AGENDA
DANIA BEACH CITY COMMISSION
REGULAR MEETING
TUESDAY, MARCH 13, 2018 - 7:00 PM

A RESOLUTION OF THE CITY COMMISSION OF THE CITY OF DANIA BEACH, FLORIDA, APPROVING THE SITE PLAN (SP-101-17), VARIANCES (VA-04-18, VA-05-18, VA-06-18, VA-10-18), AND APPROVAL OF DECLARATION OF RESTRICTIVE COVENANTS, SUBMITTED BY STIRLING ALYA LLC FOR PROPERTY LOCATED AT 2851 STIRLING ROAD IN THE CITY OF DANIA BEACH, FLORIDA AS LEGALLY DESCRIBED IN EXHIBIT “A” (“PROPERTY”), A COPY OF WHICH IS ATTACHED TO THIS RESOLUTION; PROVIDING FOR CONDITIONS; PROVIDING FOR CONFLICTS; FURTHER, PROVIDING FOR AN EFFECTIVE DATE. *(Continued from February 13, 2018)*

A RESOLUTION OF THE CITY COMMISSION OF THE CITY OF DANIA BEACH, FLORIDA, APPROVING THE SITE PLAN (SP-126-17), VARIANCES (VA-127-17 and VA-128-17), AND SPECIAL EXCEPTION (SE-129-17) SUBMITTED BY LEIGH ROBINSON KERR & ASSOCIATES, INC., ON BEHALF OF FLORIDA POWER & LIGHT COMPANY FOR PROPERTY LOCATED AT 3801 SW 43RD COURT IN THE CITY OF DANIA BEACH, FLORIDA, AS LEGALLY DESCRIBED IN EXHIBIT “A”, A COPY OF WHICH IS ATTACHED TO THIS RESOLUTION; PROVIDING FOR CONFLICTS; FURTHER, PROVIDING FOR AN EFFECTIVE DATE.

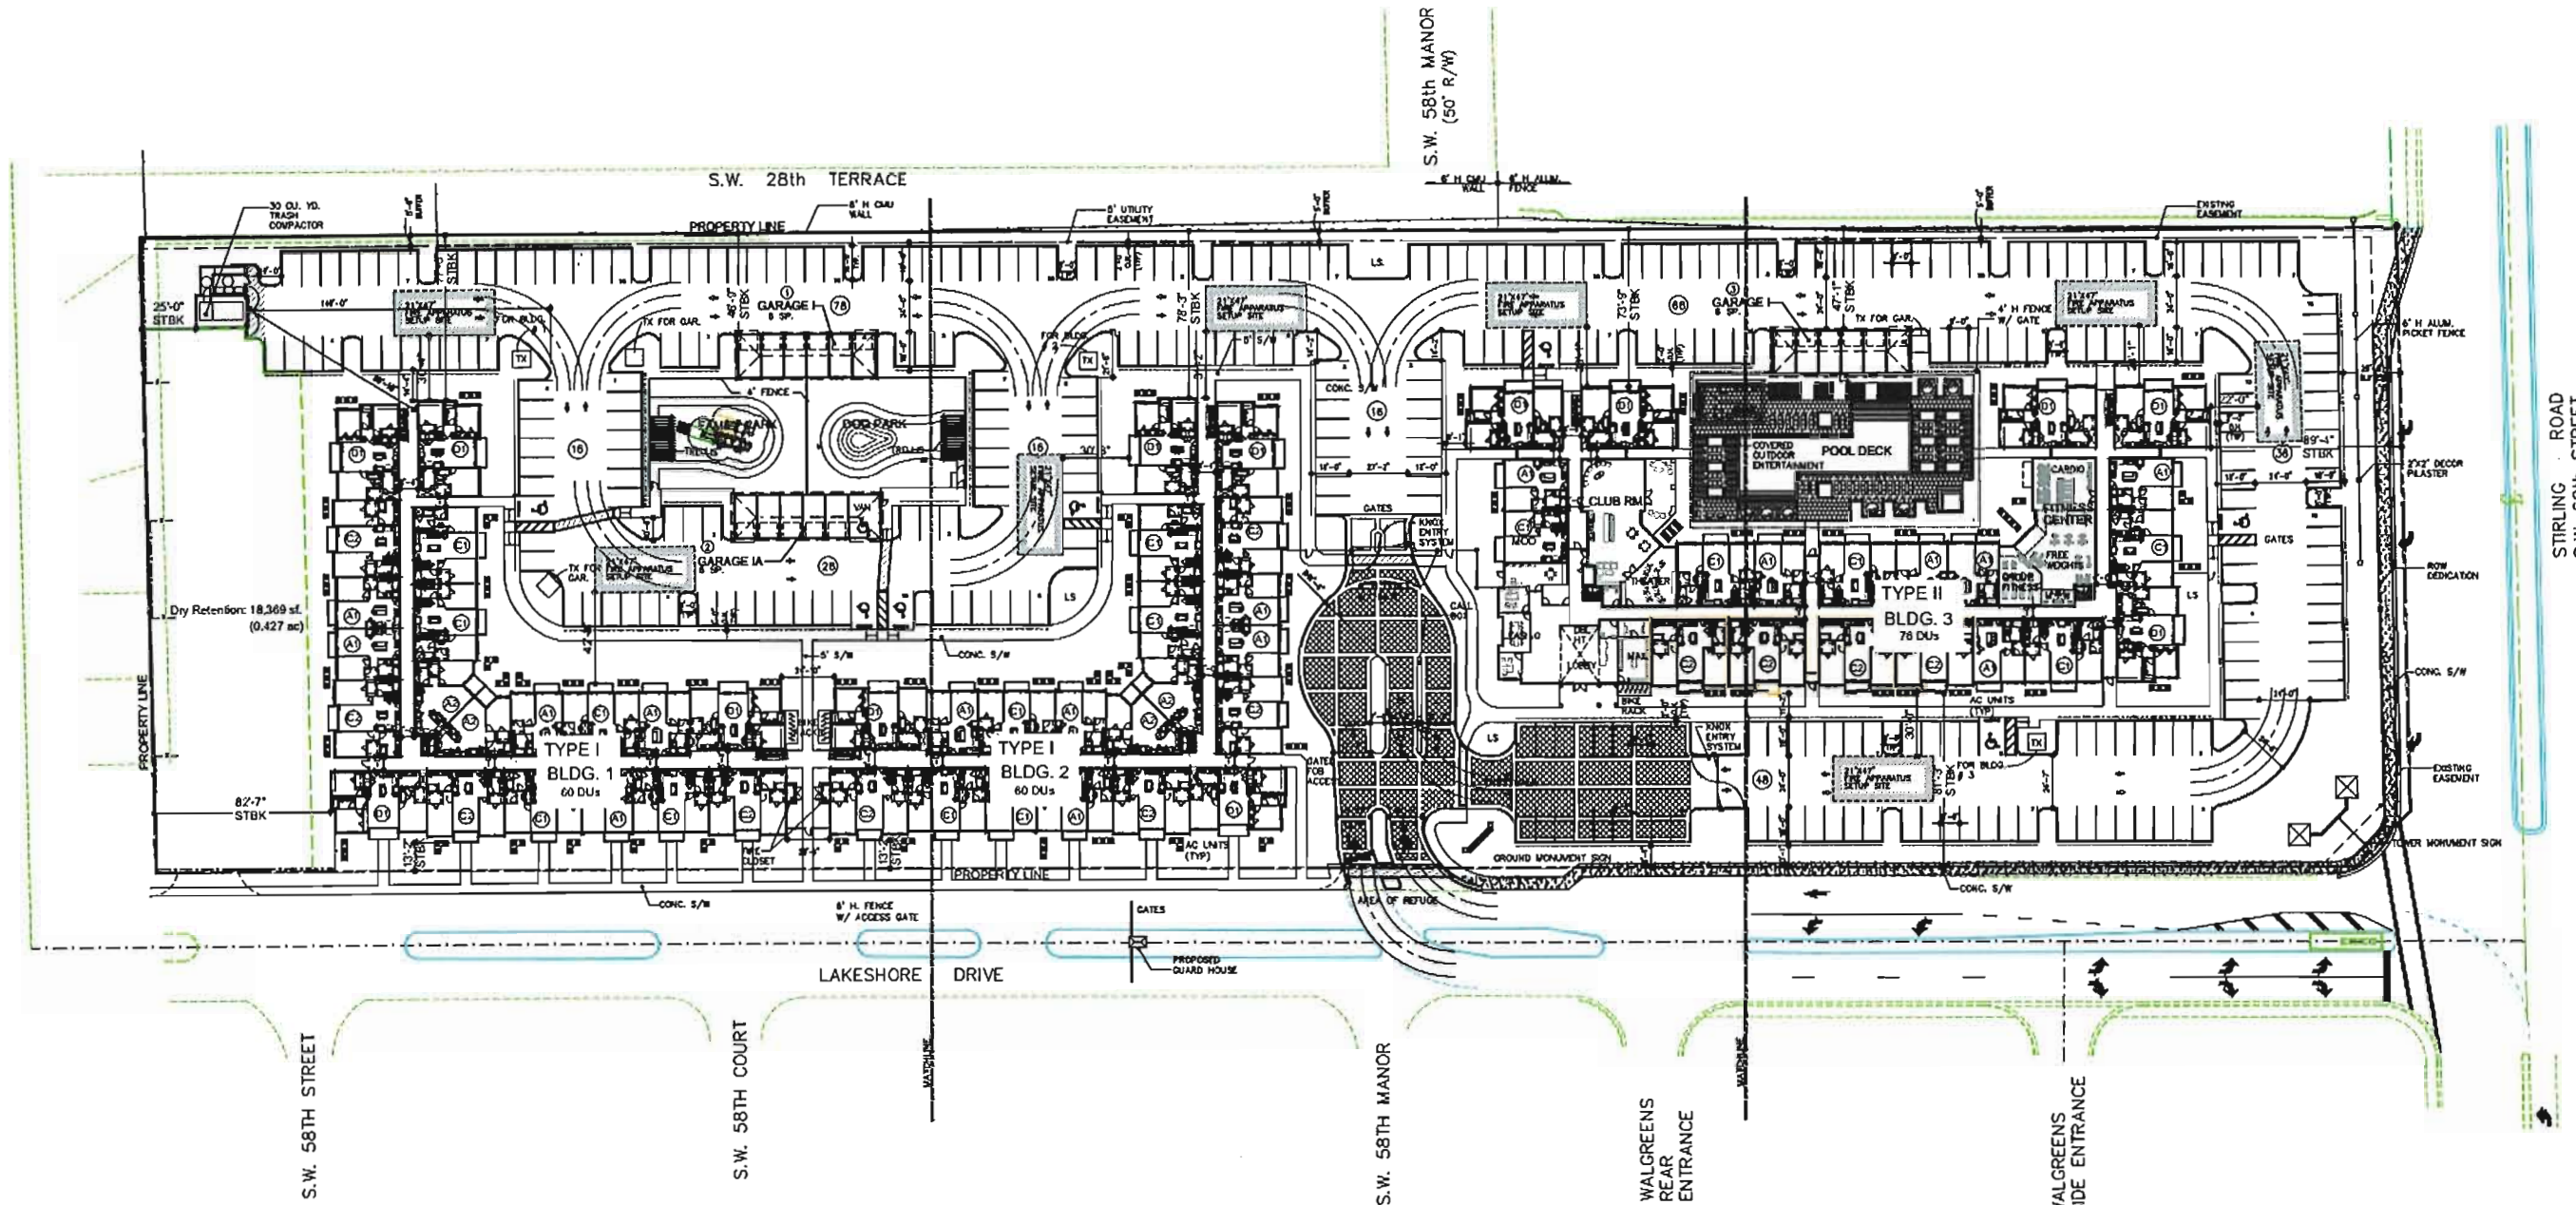
13. Sheet SP-1 revise Site Information table to identify "Low (5) Residential Land Use" as Past Land Use designation (PLANNING).
14. Sheet SP-1 Revise Regulatory Guidelines to identify "Allowed Max – 23.74 du/gross acres (201)" (PLANNING).

15. Sheet SP-1 drawing shows setback from Stirling Road as 89'4"; Regulatory Guidelines table identifies 93'. Revise accordingly (PLANNING).
16. Sheet SP-1 drawing shows setback from Lakeshore Drive at 13'2"; Regulatory Guidelines table identifies 15'. Revise accordingly. Sheet SP-1 drawing shows setback from rear as 40'74"; Regulatory Guidelines table identifies 46'9"/73'9". Revise accordingly (PLANNING).

17. Sheet SP-1 drawing shows interior side setback as 15'82'10"; Regulatory Guidelines table identifies 11'8"/90'. Revise Accordingly (PLANNING).
18. Per Section 265-110(I)(1) all required off-street parking spaces shall be clearly delineated by a single 4" wide, white painted striping. Revise parking stall detail on Sheet C6 accordingly (PLANNING).

31. Sheet SP-1 revise Site Information table to identify "Low (5) Residential Land Use" as Past Land Use designation.
32. Sheet SP-1 Revise Regulatory Guidelines to identify "Allowed Max – 23.74 du/gross acres (201)".

33. Sheet SP-1 drawing shows setback from Stirling Road as 89'4"; Regulatory Guidelines table identifies 93'. Revise accordingly.
34. Sheet SP-1 drawing shows setback from Lakeshore Drive at 13'2"; Regulatory Guidelines table identifies 15'. Revise accordingly.

35. Sheet SP-1 drawing shows setback from rear as 40'74"; Regulatory Guidelines table identifies 46'9"/73'9". Revise Accordingly.
36. Sheet SP-1 drawing shows interior side setback as 11'8"/90"; Regulatory Guidelines table identifies 15'82'10". Revise Accordingly.

FLOOD AND STAGE ELEVATIONS:
B.F.E. = 6.00 NAVD
D.F.E. = B.F.E. + 1 = 7.00 NAVD
10-YR 24 HR PEAK STAGE = 6.29 NAVD
25-YR 72 HR PEAK STAGE = 7.00 NAVD
100-YR 72 HR PEAK STAGE = 7.29 NAVD
PROPOSED F.F.E. = 7.00 NAVD

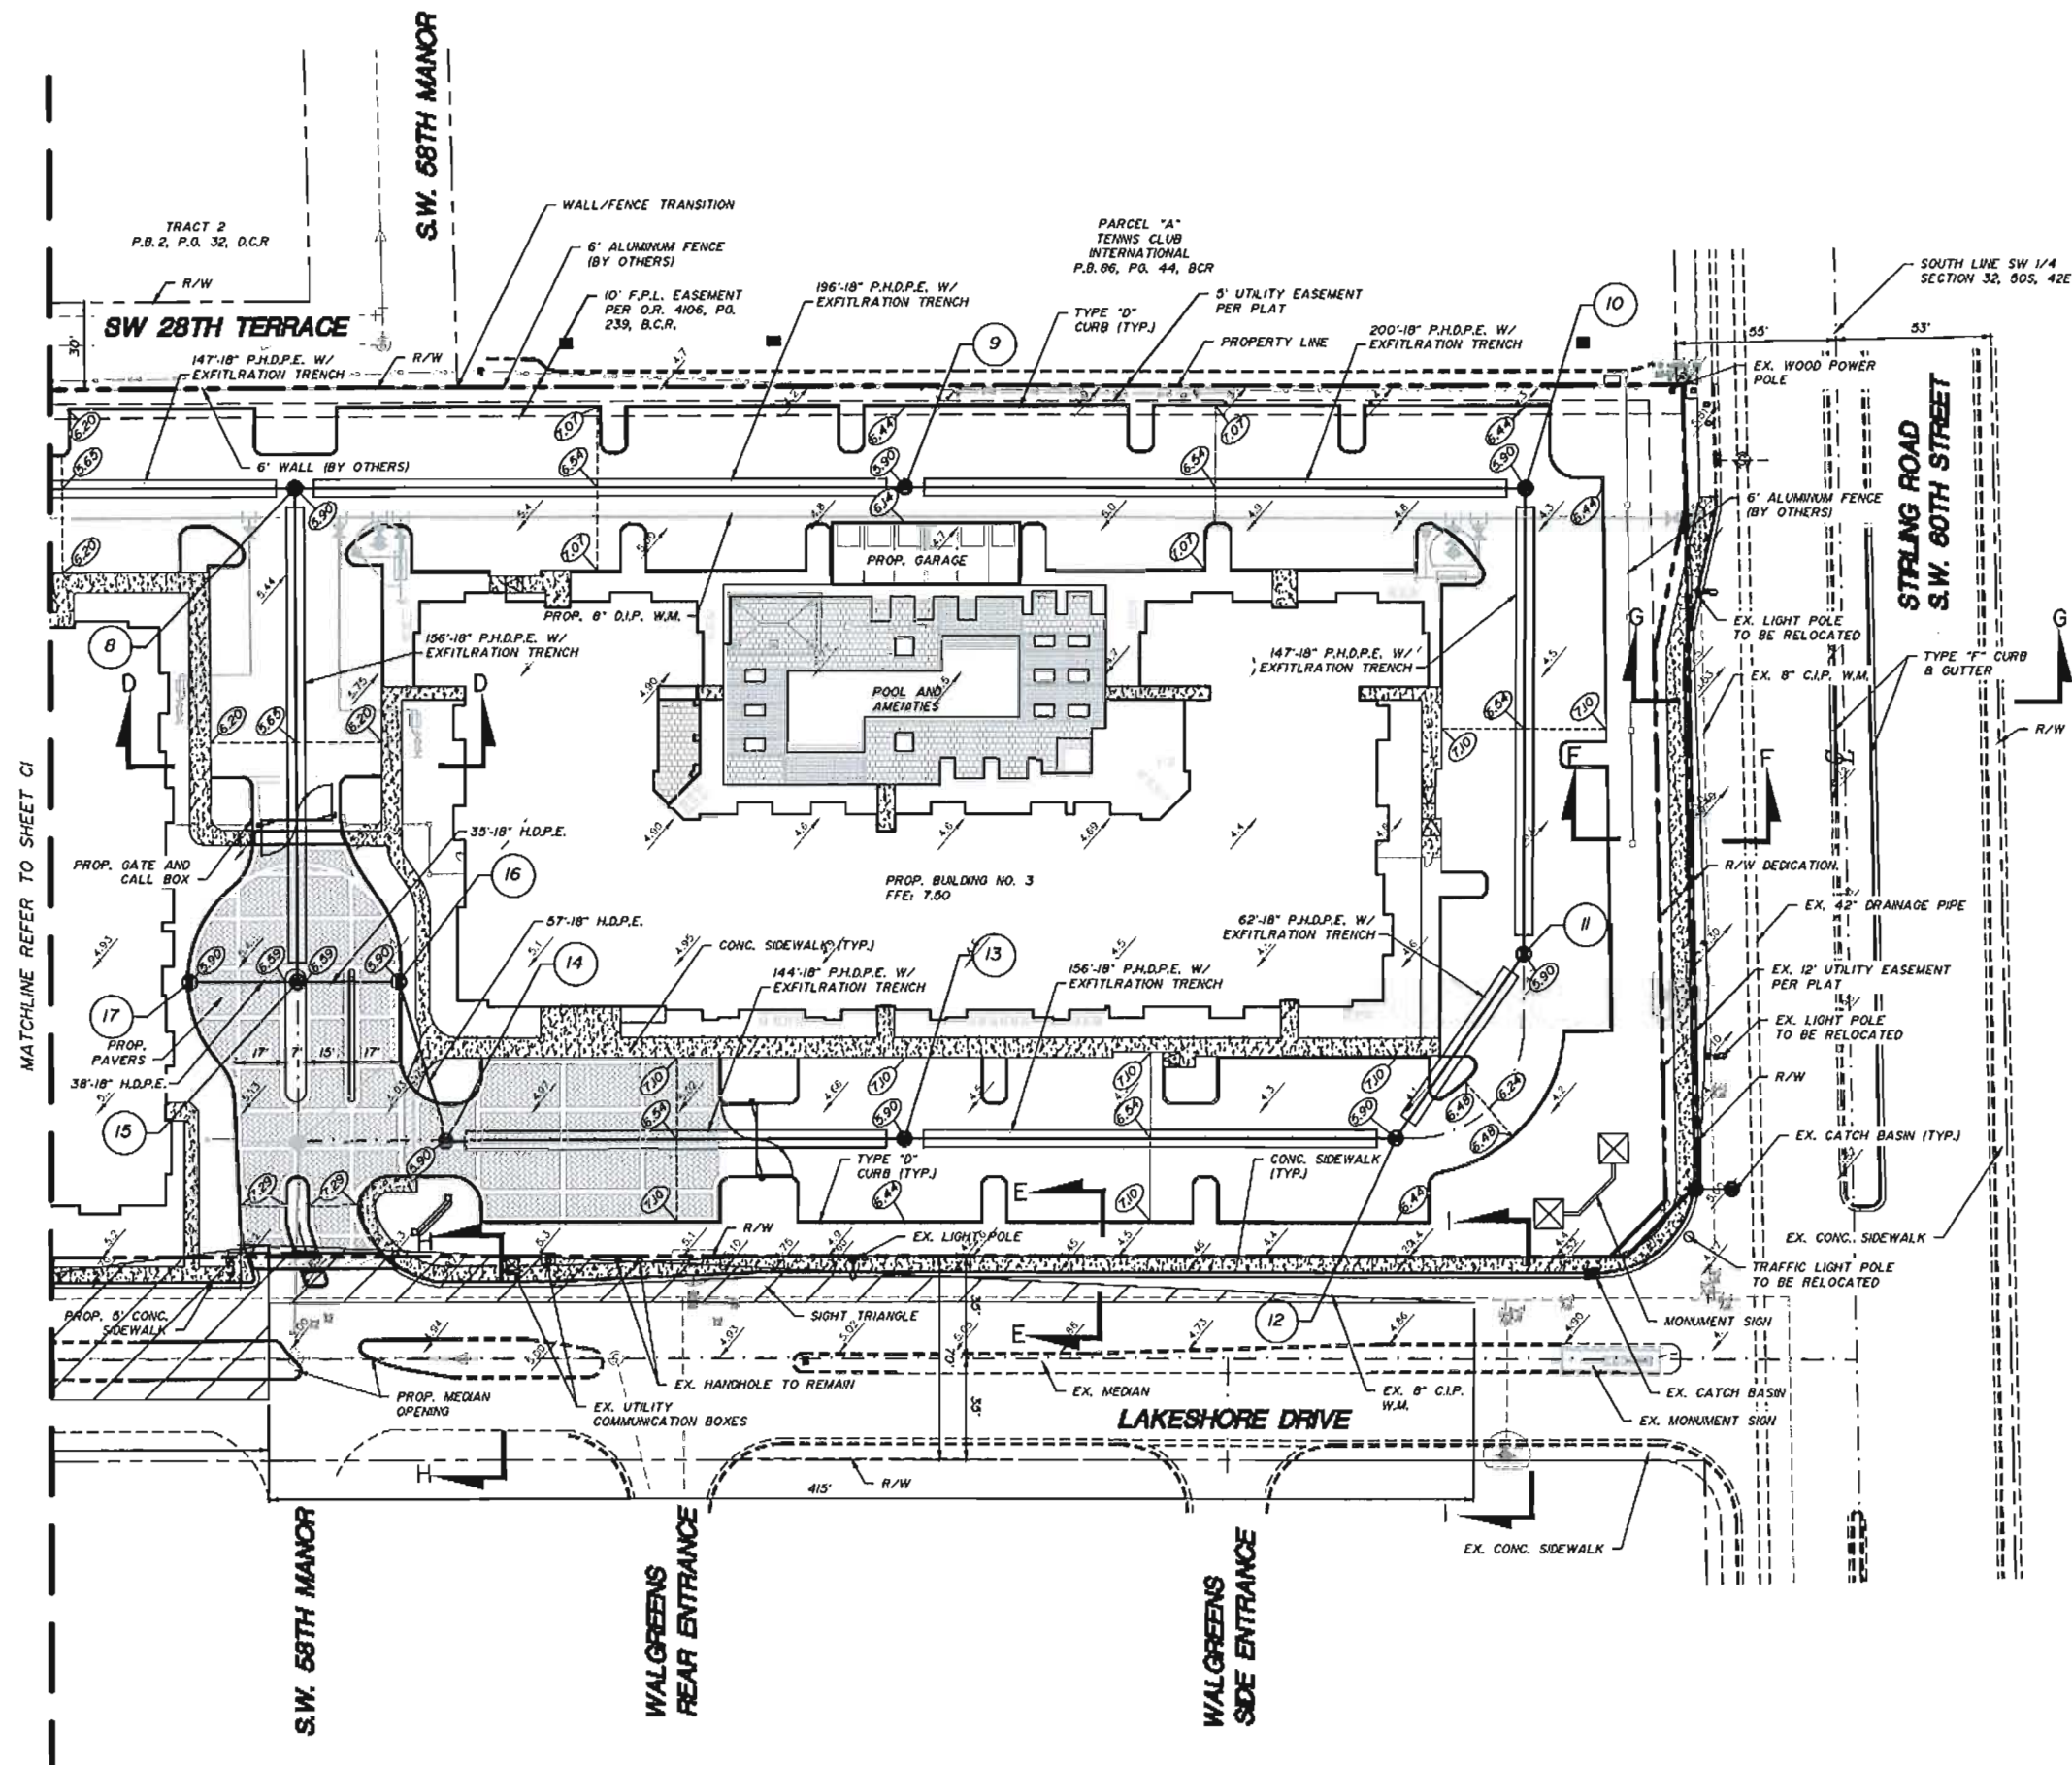
Sheet C1 and C2: Please revise to indicate datum of proposed elevations.

RESPONSE: Sheet C1 and C2 have been revised to indicate NAVD datum.

RESPONSE: Sheet C-1 and C-2 have been revised to shwo the base flood elevation (BFE), finished floor elevation (FFE), peak stages for 10-yr, 25-yr and 100-ry rain events.
